# UNITED STATES PATENT AND TRADEMARK OFFICE

10/597,814

<b>Office Action Summary</b>	<b>Application No.</b> 10/597,814	<b>Applicant(s)</b> NEWMAN ET AL.	
	<b>Examiner</b> CARLOS LUGO	<b>Art Unit</b> 3673

### DETAILED ACTION

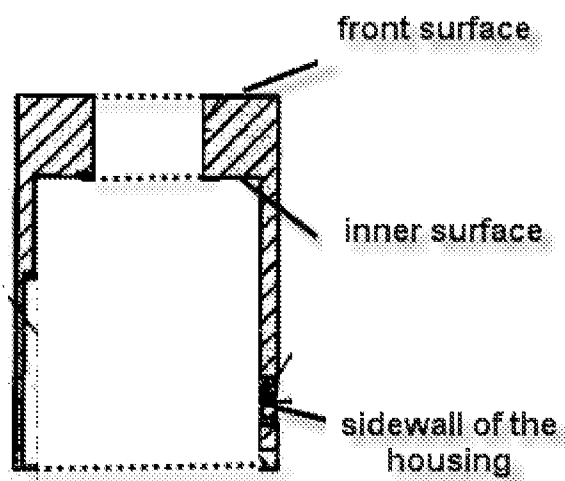
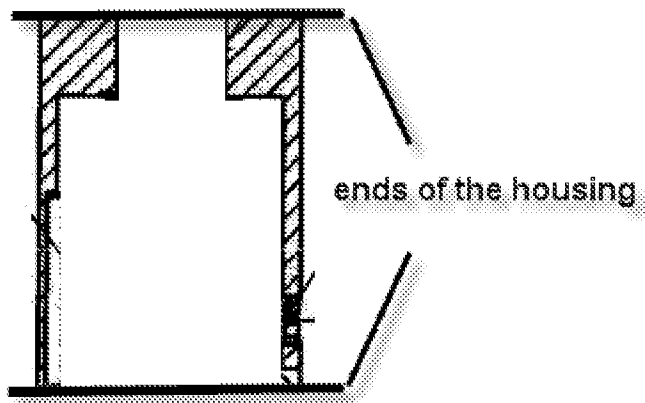
As to the 112 2<sup>nd</sup> paragraph rejection, the arguments are not persuasive and the rejection is maintained. The rejection was to claims 1 and 13. As seen in attachments #1 and #2, the housing is a cylinder having an open end and an opposed end. The opposed end has a front and an internal surface. A channel or hole is provided to communicate both surfaces.

The spigot tail is introduced into the hole and the spigot is secured to the housing by using a spring clip 26 that rest on the internal surface of the housing, not to the end of the housing.

Also, the mounting stock is introduced into the open end so that the stock can be attached to the housing by using a screw through an opening on a sidewall of the housing, not the end.

At the instant, in order to speed the process, the examiner suggest that the applicant should define the housing as explained in the 112 2<sup>nd</sup> paragraph section above, that is a cylinder having an open end and an opposed end. The opposed end has a front and an internal surface. A channel or hole is provided to communicate both surfaces and that the spigot tail is introduced into the hole and the spigot is secured to the housing by using a spring clip 26 that rest on the internal surface of the housing and the stock is introduced into the housing and secured to the housing using a securing means (screw) though a hole in the sidewall of the housing (see the attachments).
